Deviation Request ETSO-2C197#4 for an ETSO approval for CS-ETSO applicable to Information Collection and Monitoring Systems (ETSO-2C197)

Consultation Paper

2 ETSO-2C197#4 Information Collection and Monitoring Systems

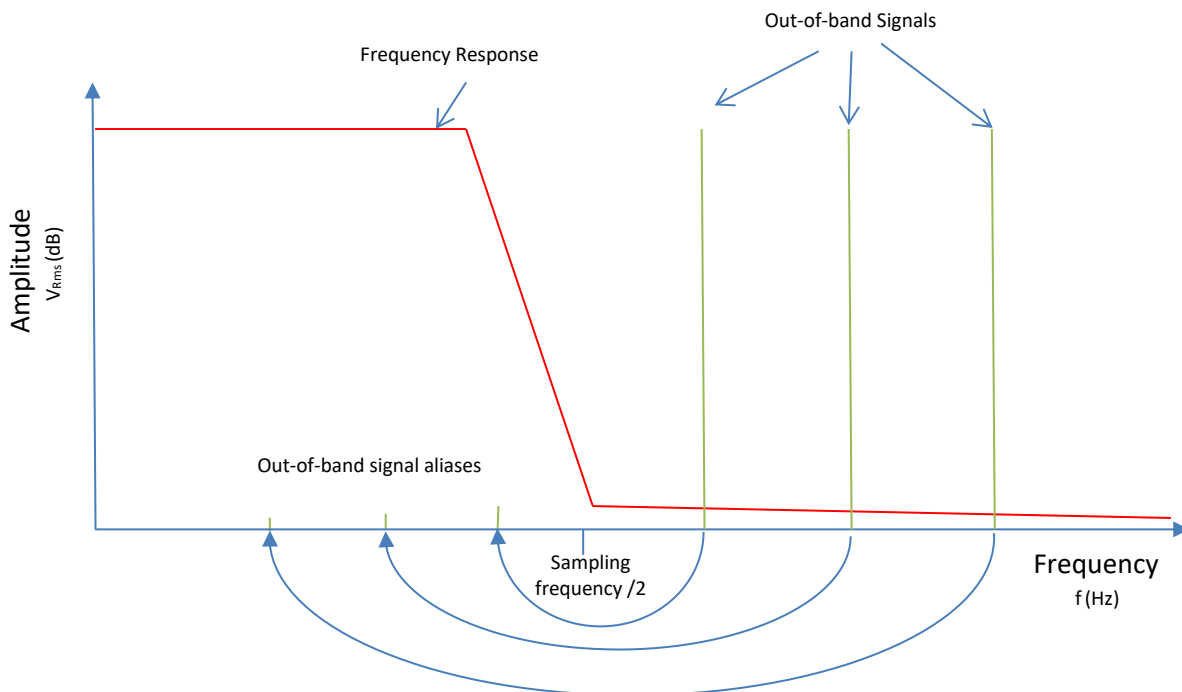
Empirical testing has demonstrated that it is possible to achieve signal to noise ratios ranging from 55 dB to 74 dB by using different cable set-ups (all performed with Shielded Twisted Pair (STP)). The value of 80 dB is considered excessive as this has not been achieved using different cabling.

Firstly, to meet this requirement would require an anti-aliasing filter sufficient to attenuate the out-of-band signals. This would be necessary to avoid signal aliases within the required frequency band (see graph below). However, such a filter design would also impart a recording delay and adversely affect pass-band ripple to marginal levels.

As an alternative means of compliance, it is suggested that a threshold of 70 dB would be more realistic, even for installations where a combined recorder is used with all interfaces active.
